Street and Bicycle/Pedestrian Framework Recommendations from Thrive Hood River

Alternative Sections for Arterials:

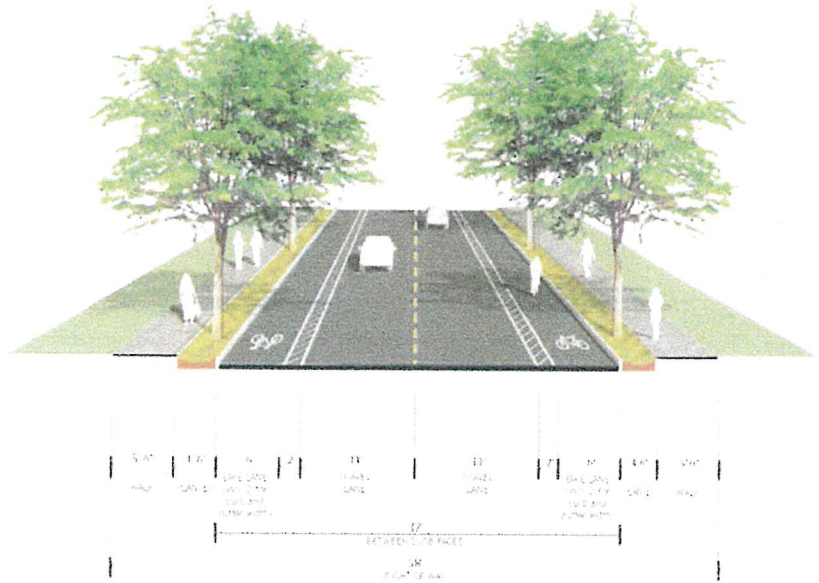
The sections for arterials (Cascade Ave., Alignment D and the Post Canyon/Belmont extension) in the Westside Plan are shown with unprotected bike lanes, where bikes are separated from vehicular traffic by nothing more than paint as shown at right:

Thrive’s Recommendation: For streets with a high volume of vehicular traffic, provide bike facilities that are separated from vehicular traffic. Here are two examples.

1. Henderson Creek and Ridgeline Trails:

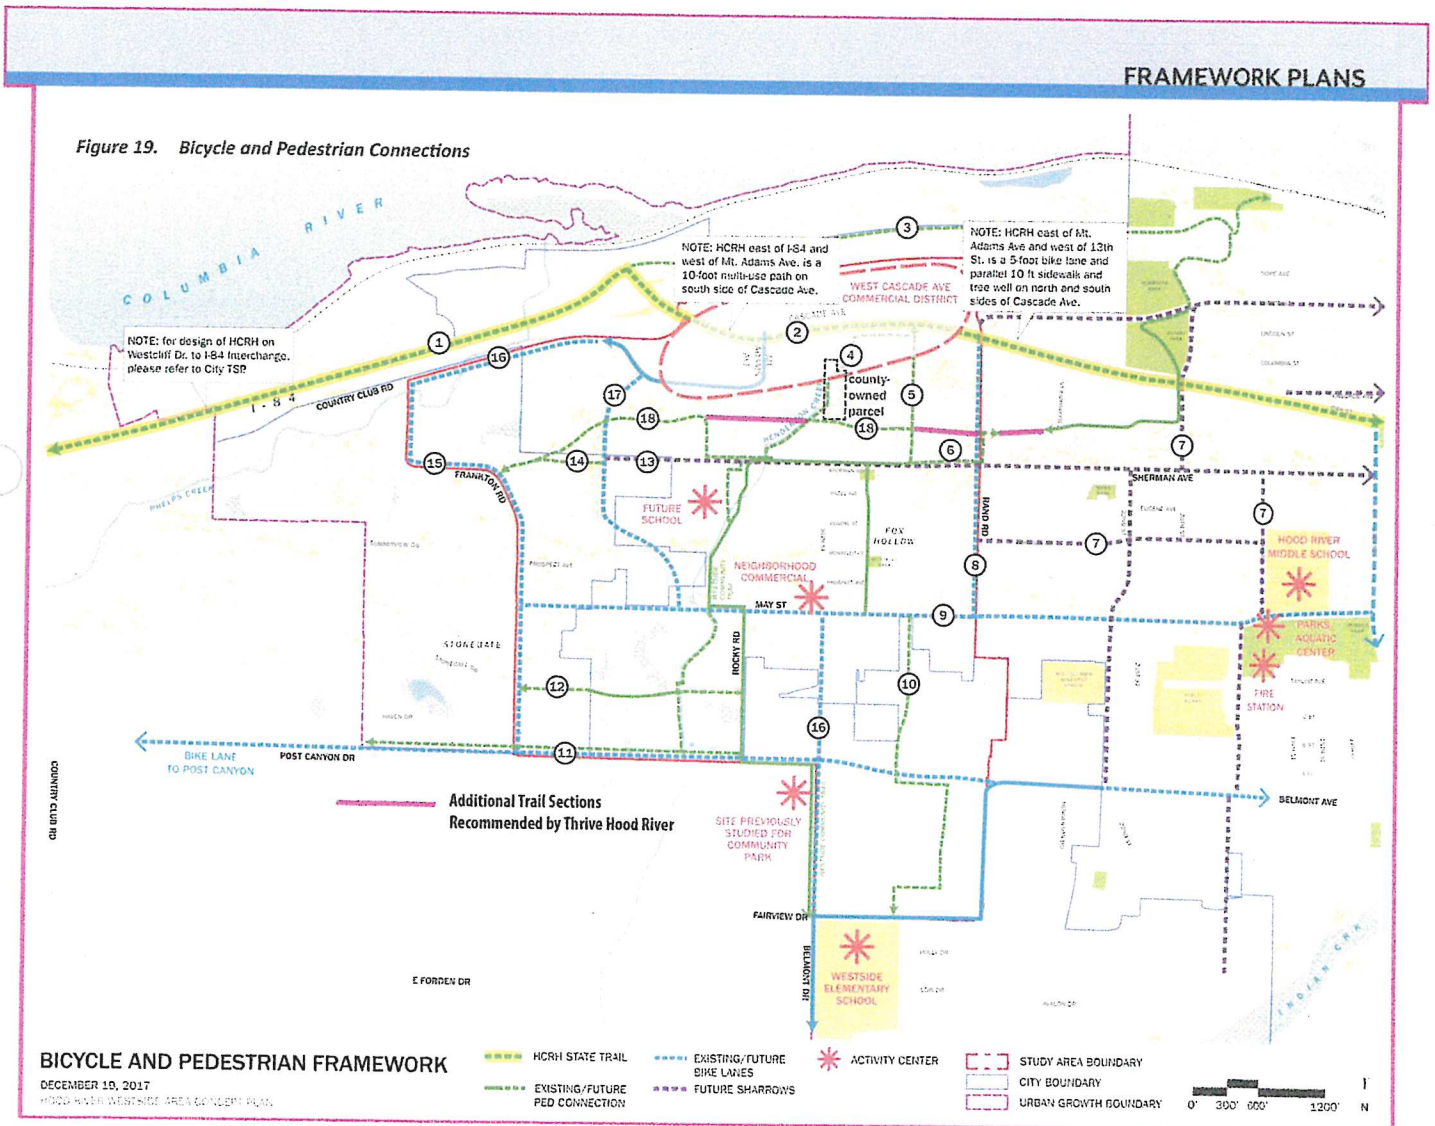
Thrive strongly supports these proposed trails with several additional recommendations:

- Consider making them wider (10') multi-use paths like the Westside Community Trail. Along Henderson Creek, consider making the trail corridor 30' to 50' wide to retain more of the natural stream edge and vegetation.
- The proposed trail takes several diversions that take the trail away from its natural route and direct the trail onto sidewalks along city streets. We believe a true, continuous off-road trail is a better asset for the community. The sections shown in pink below illustrate our preferred route which would allow true east-west connectivity. The trail over Mt. Adams extension would likely need to be a pedestrian bridge because the road will require significant excavation.
